# ADDENDUM

Date Issued:	July 28, 2025
Project:	Intermountain Health Alta View Hospital – IR Rad Room #2 Remodel 9660 South 1300 East Sandy, Utah 84094
Addendum Number:	1

## IR Rad Room #2 Remodel

NJRA Project # 24239.00  
Construction Documents June 4, 2025  
I Addendum I July 28, 2025

G001

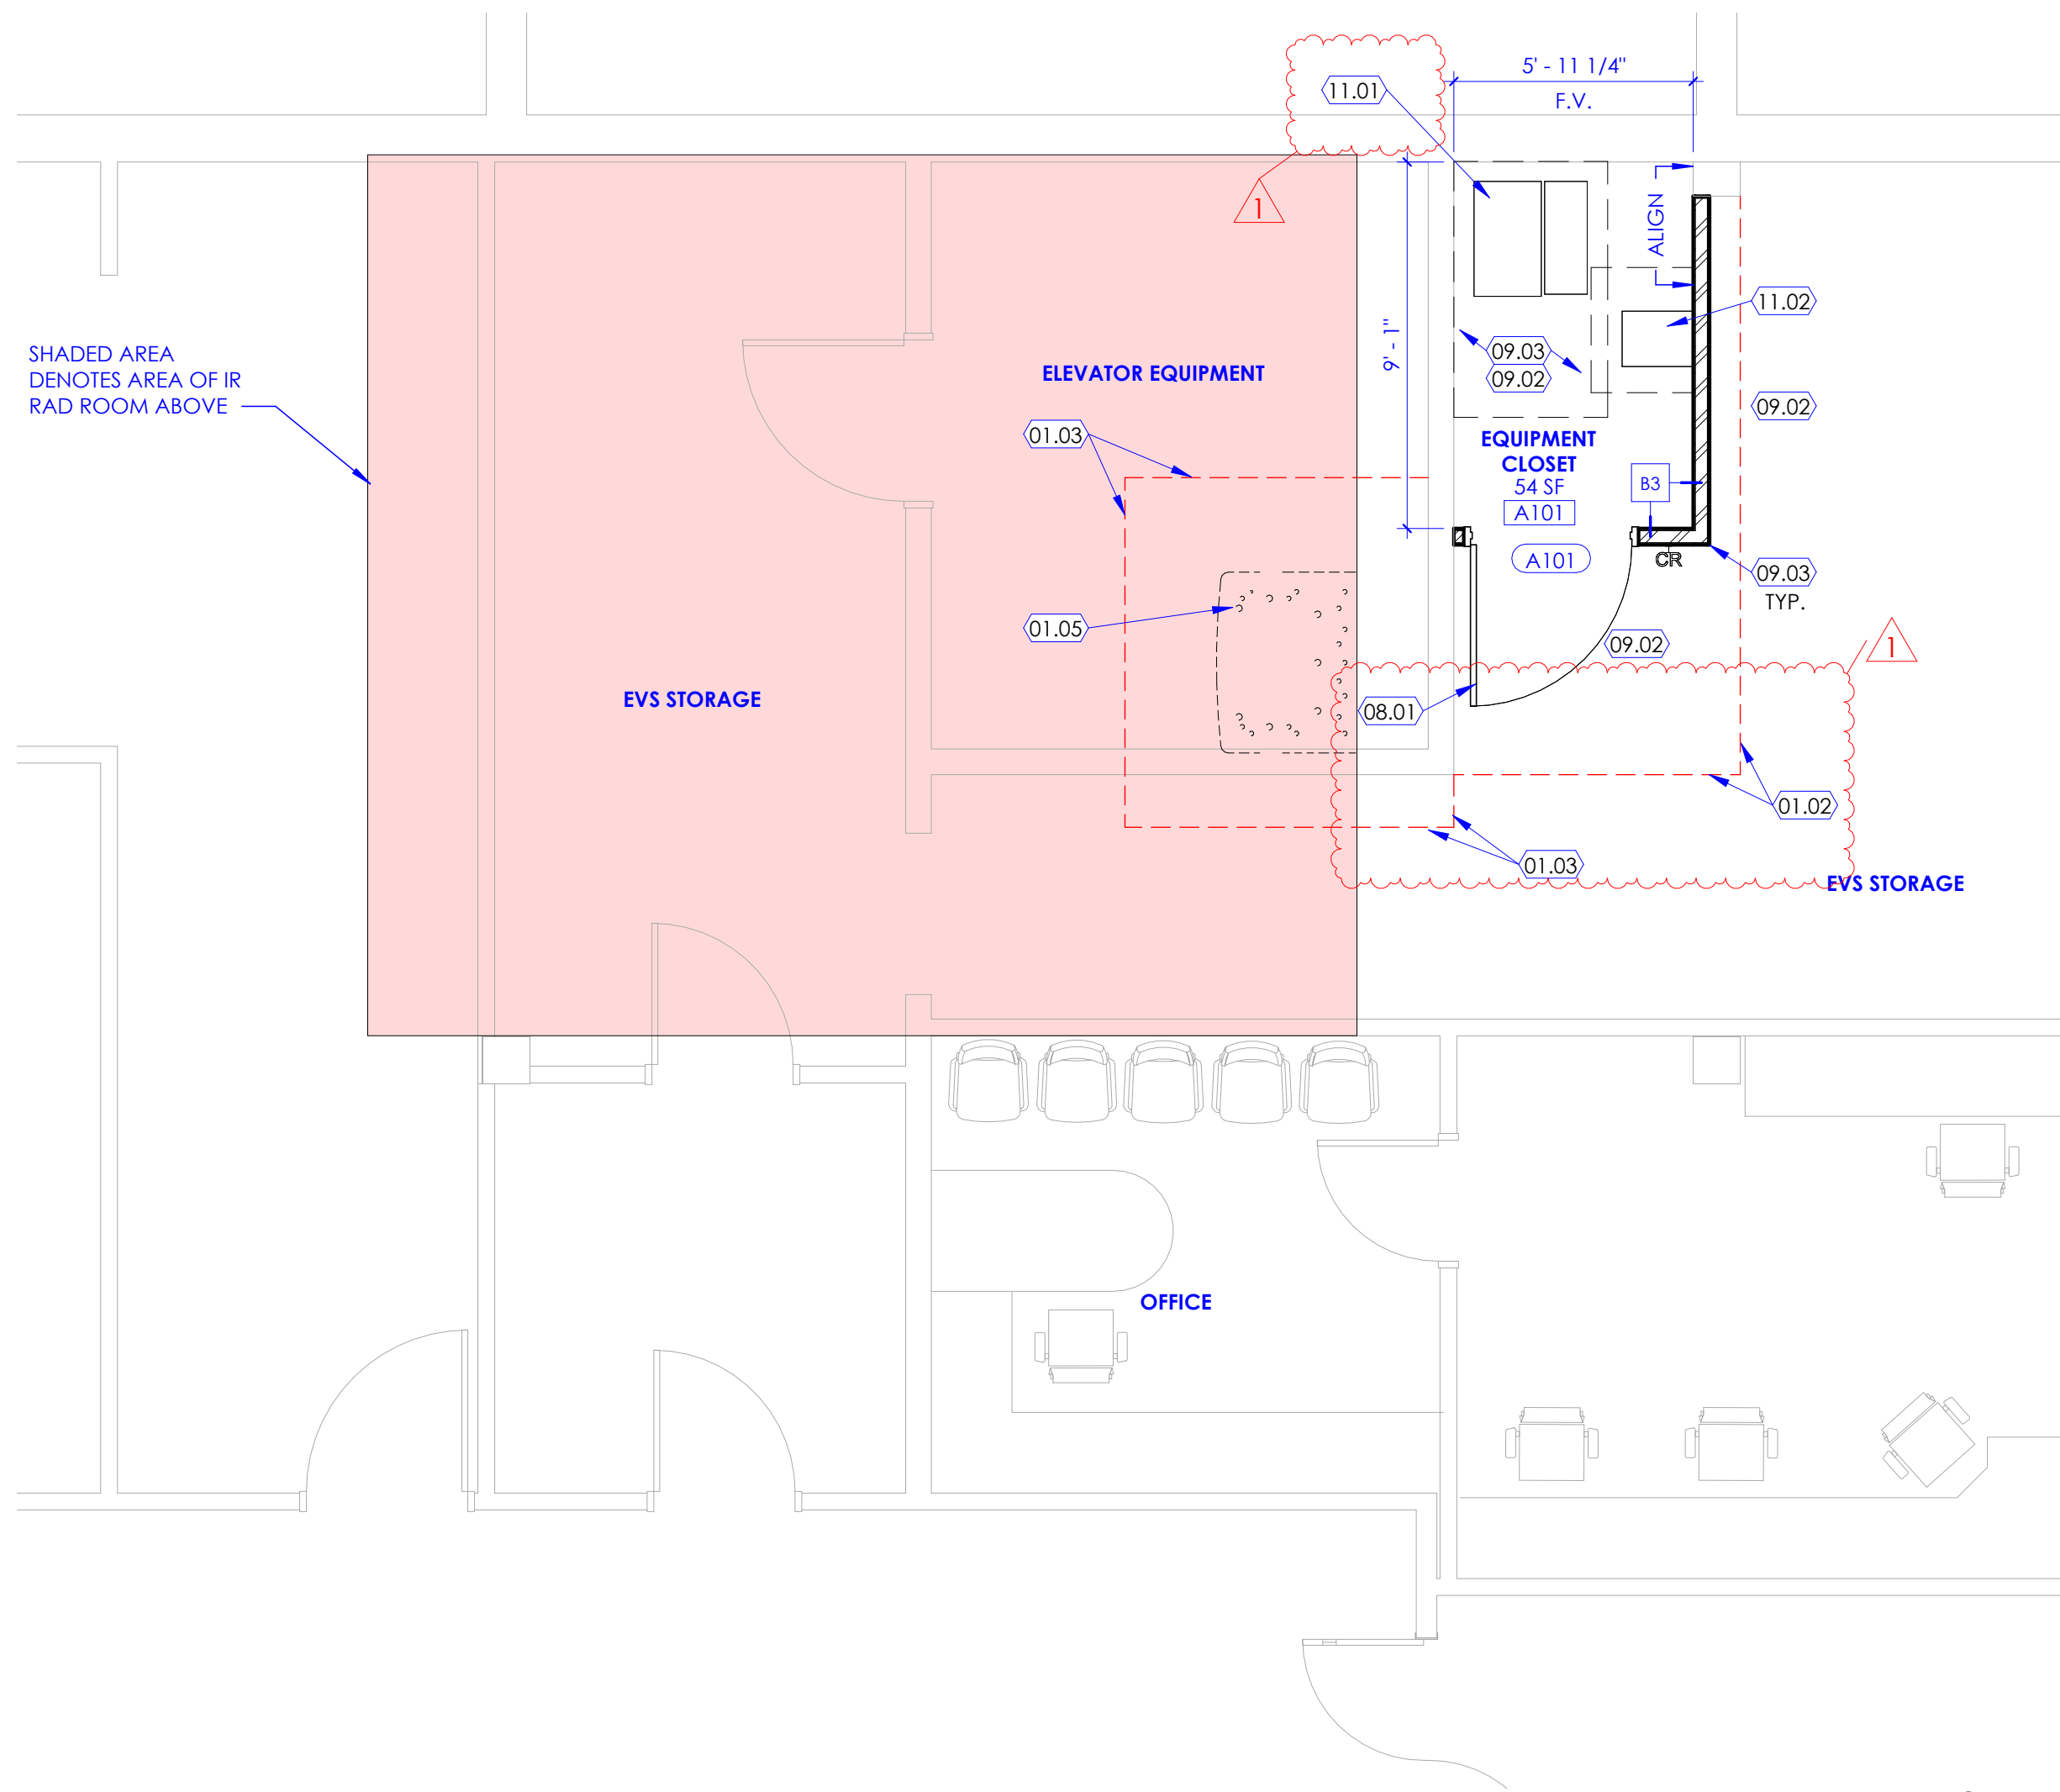
Sheet Number	Drawings
<b>Architectural Drawings</b>	
G001	Revised equipment note to reference Siemens for manufacturer equipment drawings.
A113	Revised keynote 01.02 to give preference for prefabricated construction barriers at solid wall barrier locations Revised keynote 01.03 To clarify visqueen sheeting type construction barrier requirements. Add keynote 08.01 to clarify new door and frame. Revise keynote 11.01 to coordinate with electrical one-line diagram. Add keynote 23.02 to include backing requirements for inline fan.
A121	Revised keynotes 01.02 and 01.03 per previous comment. Add keynote 02.09 to protect the existing lead lined shielding window. Add keynote 02.11 to clarify plumbing fixtures to be protected from damage/debris during construction. Revise keynote 02.30 to clarify cabinet to be relocated. Add keynote 06.13 for location to provide vertical casework fascia. Revise keynote 06.15 to provide fascia for exposed side of relocated base cabinet. Revise keynote 13.04 for lead shielded wall patching.

SIEMENS DRAWINGS FOR XRAY UNIT INSTALLATION HAVE BEEN INCLUDED AS PART OF THE CONSTRUCTION DOCUMENTS FOR COORDINATION PURPOSES. THE OWNER, INTERMOUNTAIN HEALTH, SHALL PAY SIEMENS DIRECTLY FOR THEIR CONSTRUCTION WORK. GENERAL CONTRACTOR AND SUB-CONTRACTORS SHALL COORDINATE WITH SIEMENS INSTALLATION DRAWINGS, AND PROVIDE REQUIRED WORK SCHEDULING DURING CONSTRUCTION. ITEMS MENTIONED AS "PROVIDED BY OTHERS" IN THE SIEMENS DRAWINGS SHALL BE PROVIDED BY GENERAL CONTRACTOR AND THEIR SUB-CONTRACTORS. IF THERE IS ANY CLARIFICATION REQUIRED, CONTRACTORS SHALL CHECK WITH THE A/E DESIGN TEAM DURING THE BIDDING PHASE.
